Application Note: V6.0 Board Revision

FreeETarget Version 6.0.0, serial numbers 644-690 may require a modification. If your target experiences missed shots, then this modification will likely rectify the problem.

Step 1. Disconnect U6-12

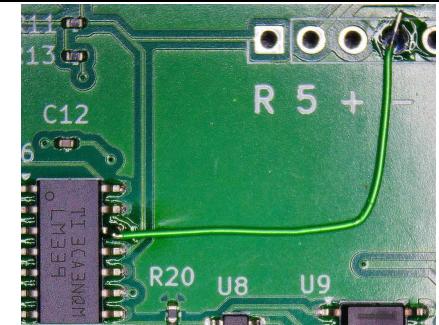
Step 1, Disconnect U6-12 from ground.

Method 1, lift pin U6-12 from the ground pad

Method 2, drill the ground via from below the pad

Step 2, Insert a jumper between U6-12 and the -5V test point

Lift pin U6-12

Ensure that there is no solder between the pin and the pad

Drill Via

below board (Underneath U6)
Verify that U6-12 is not connected to ground (test point G)

Jumper U6-12 to test point –

Apply power and verify that U6-12 receives -5Volts when measured from test point G
